Preliminary Plan of Subdivision

Resubdivision of Lots 6, 7, 8 to create 3 smaller lots, Beallsville

PROJECT NAME: Beallsville Property

120060960

ATTACHMENT B

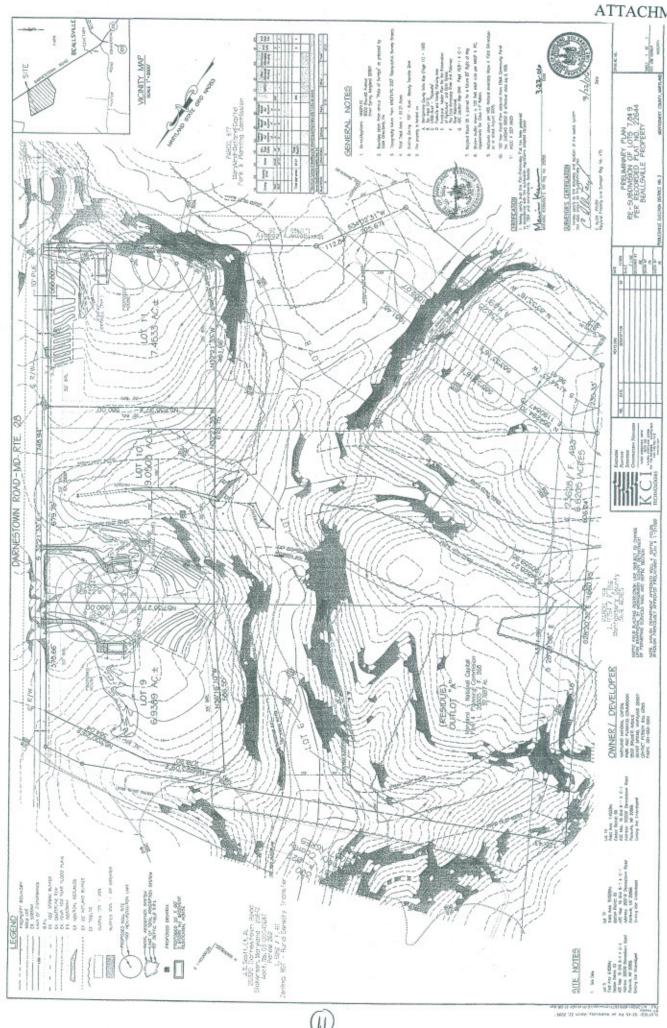
- The applicant must submit a sight distance evaluation on SHA worksheets.
- We recommend that the proposed separate entrances for lots 9 & 10 be consolidated into one use-in-common driveway entrance.

- It is our understanding that M-NCPPC's Transportation Planning Office is requiring the applicant to construct a class II bikeway – widen southbound MD 28 to provide a bike compatible shoulder across the entire development frontage with MD 28.

- Show/label all existing planimetric and topographic details specifically paving, storm drainage, driveways adjacent and opposite the site, sidewalks and/or bikeways as well as existing rights of way and easements on the preliminary plan.
- Necessary dedication for Darnestown Road in accordance with the master plan.
- Grant necessary slope and drainage easements. Slope casements are to be determined by study or set at the building restriction line.
- Wells and septic systems cannot be located within the right of way nor slope or drainage easements.
- Access and improvements along Darnestown Road (MD 28) as required by the Maryland State Highway Administration.
- Revise the plan as necessary to meet the requirements of the Montgomery County Department of Permitting Services with regard to wells and/or septic systems.
